**DESY/EFREMOV SPECTROMETER**

I used dimensions given by Peter as the following.

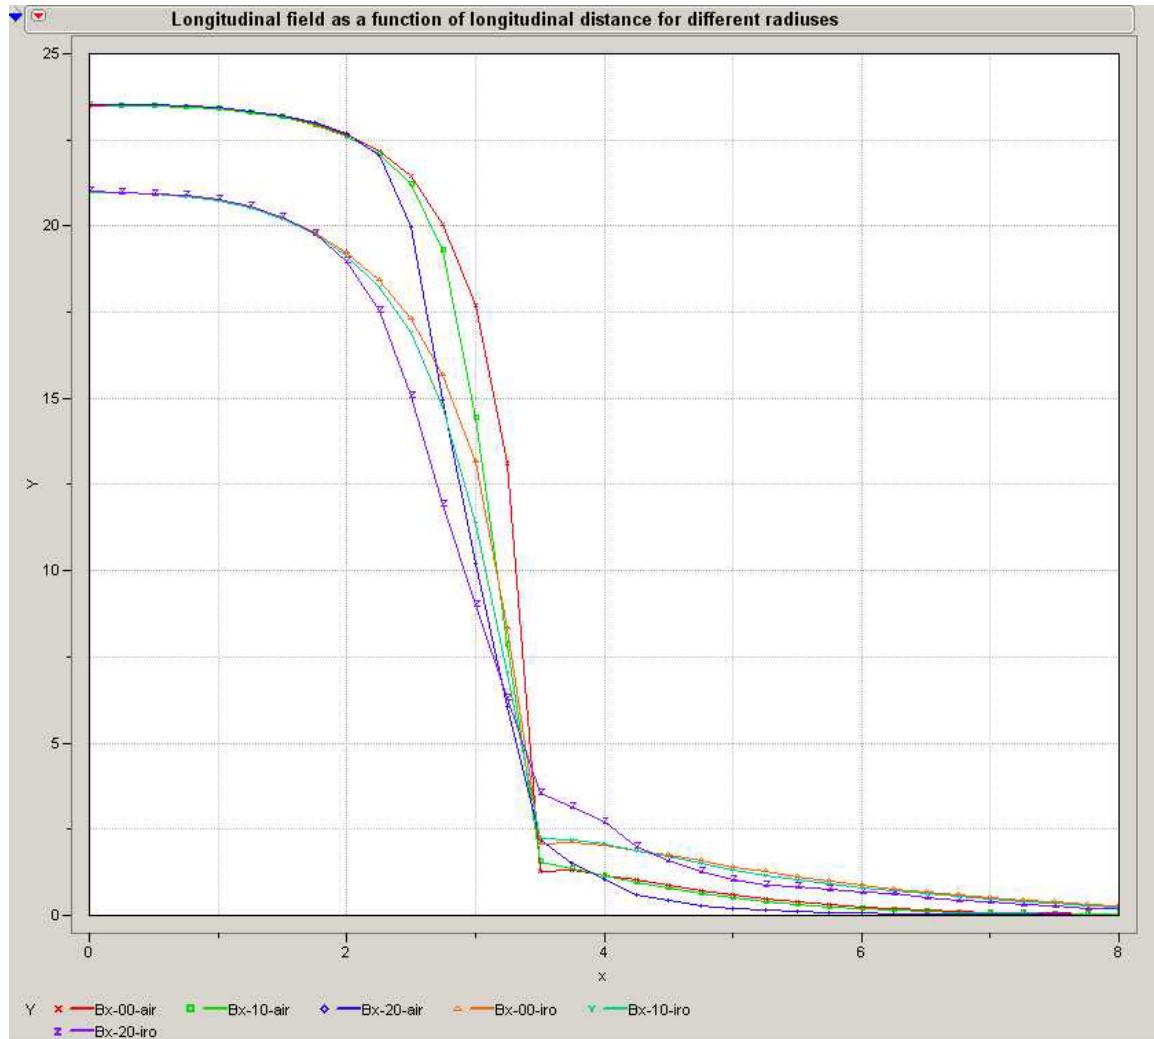
Was interested to see how the field changes if cavity filled by Led instead if iron. Also was nice to see some field homogeneities. Of cause, Led in magnetic calculations is equivalent to the Air.

These figures show how lines behave in two cases. At the top-the cavity filled by iron, at the bottom- it is Air.

Iron used in modeling Steel 10 in Russian classifications. I used 10 kA-turns of current. Despite the lines look as much more concentrated in case with Air-filled cavity, the field difference is not so impressive.

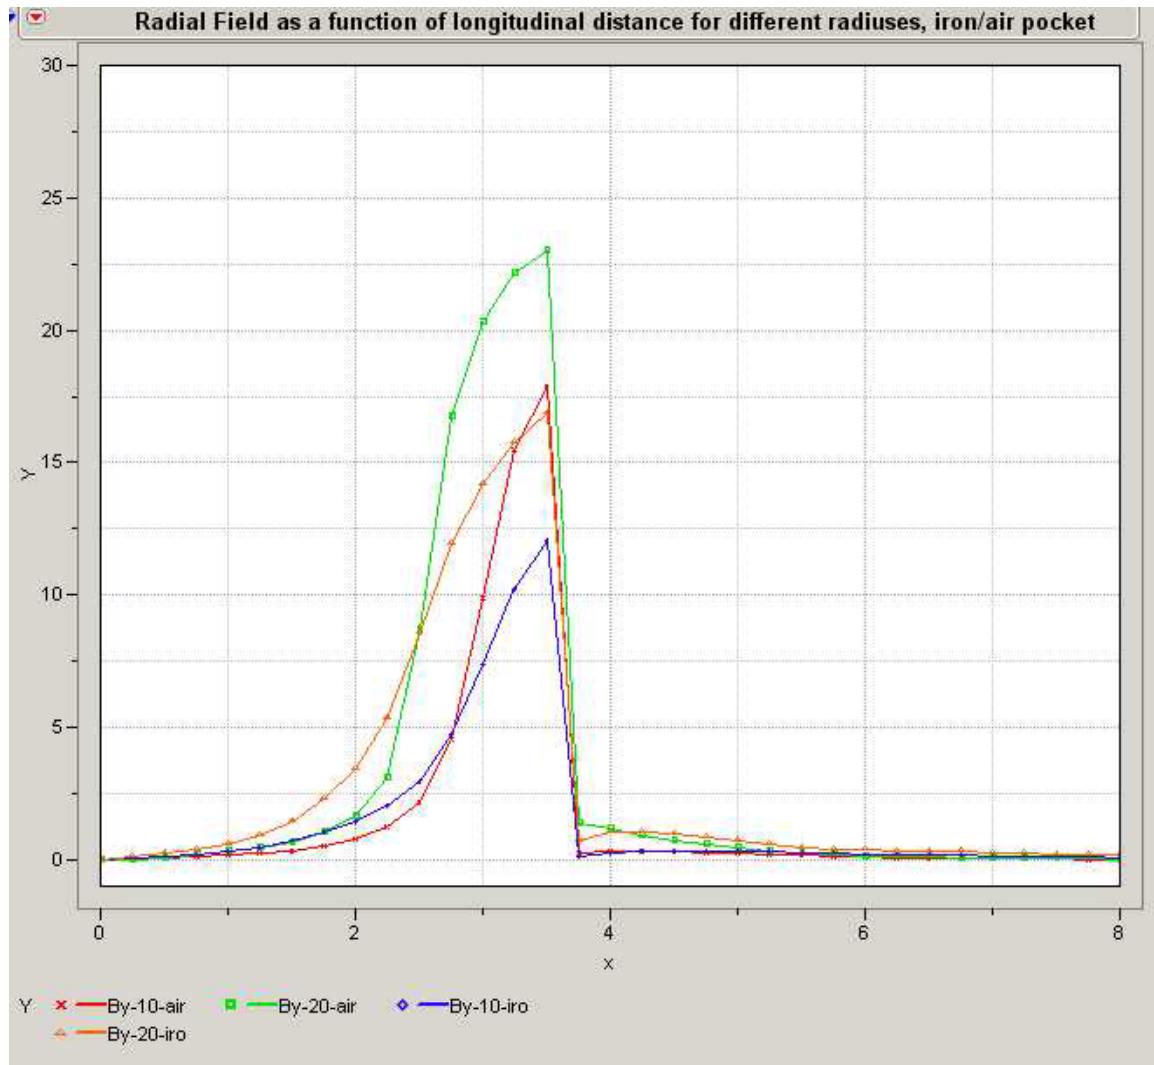
At the figure below the longitudinal field as function of longitudinal coordinates is represented. This done for three different radii: zero (at axis), 1-cm and 2-cm off center lines. All field distributions start from center of magnet.

One can see that the lines are rather smooth. Gain is field is  $\sim 12\%$  only. There is field outside the iron in region of re-conversion target.

Bx-10-air, for example means, that this is distribution for Bx taken at 10 mm radius if the cavity is Air filled. Bx-20-iro means, that this is distribution for Bx taken at 20 mm radius if the cavity is Iron filled and so on.
